To: Chief Executive, Hutt City Council

1. This is a submission from Richard Kelly on the Proposed Lower Hutt District Plan 2025.
2. My email address for service is richard.kelly@outlook.co.nz.
3. I could not gain an advantage in trade competition through this submission.
4. The specific provisions of the proposal that my submission relates to, my submission on those provisions, and the decisions I seek are shown below. I also seek all further, alternative, necessary, or consequential relief as may be necessary to fully achieve the relief sought in this submission.
5. I wish to be heard in support of my submission.
6. If others make a similar submission, I will consider presenting a joint case with them at the hearing.

7. Flood analysis

Figure 1

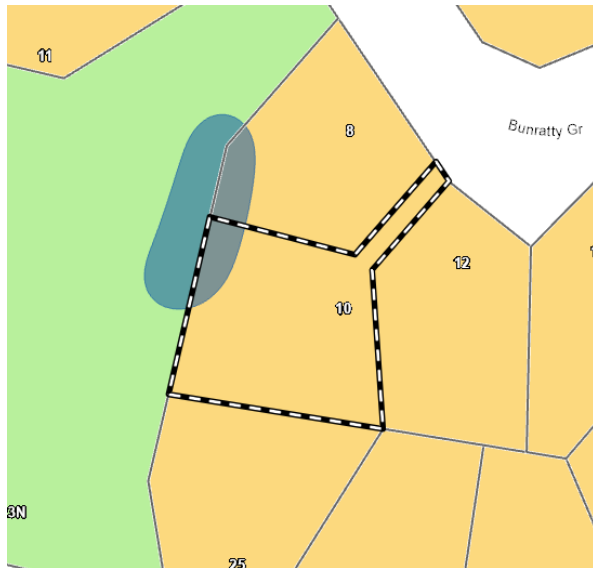
The modelling used to identify a high natural hazard area for proposed district plan must be flawed. The area shown in figure 1 is definitely not a high natural hazard area, is not prone to flooding, has never flooded in the 16 years I have owned the property or indeed in recorded or pre-history I cannot find evidence of a flood in this spot.

Figure 2

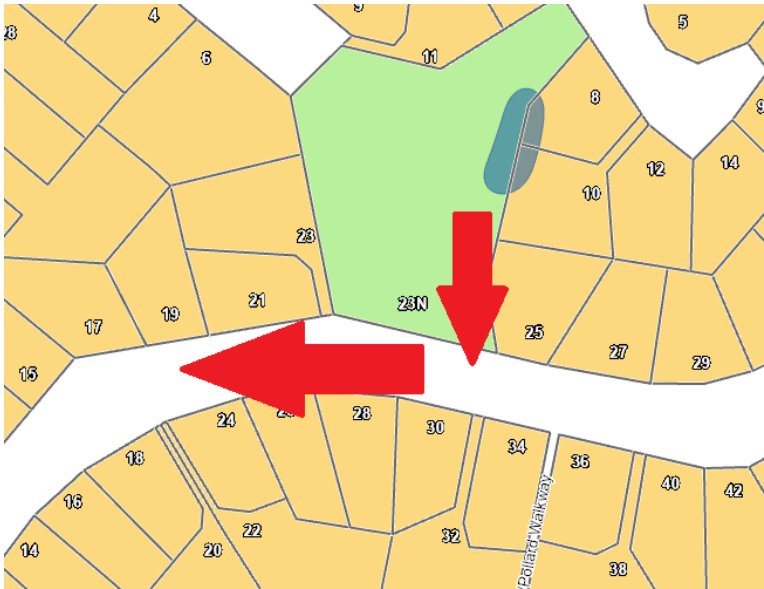
The water can't pool here because there is a downhill slope to Antrim crescent, then a downhill slope down Antrim crescent to Castlereigh Road. While I have had neither the time nor the money to conduct a profile survey, from an eyeball assessment the red arrows represent substantial grades of about 5%.
